To:
Department of Planning & Environment

23 October 2017

BIKESydney's submission to Parramatta Light Rail (Stage I) EIS

Figure 20: An indicative cross-section for the active transport link

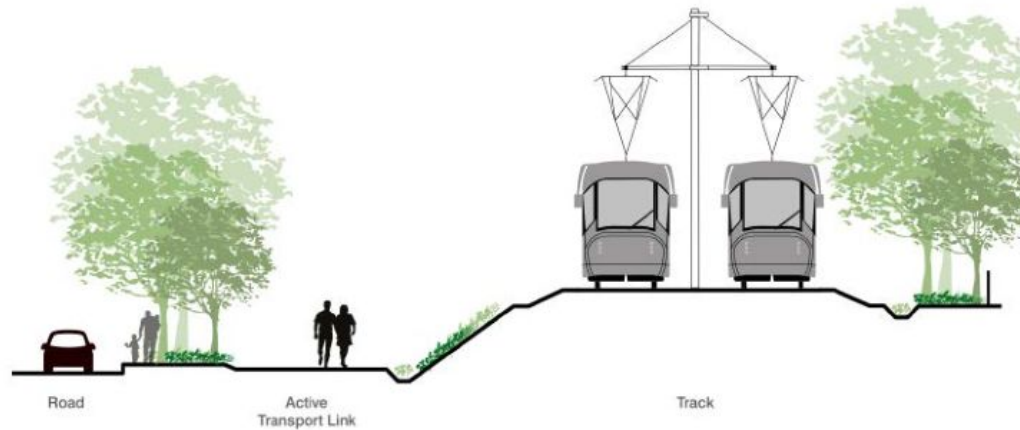
And why does the EIS exclude bike riders from its depiction of Active Transport?
It's time to enable active transport with a serious effort.
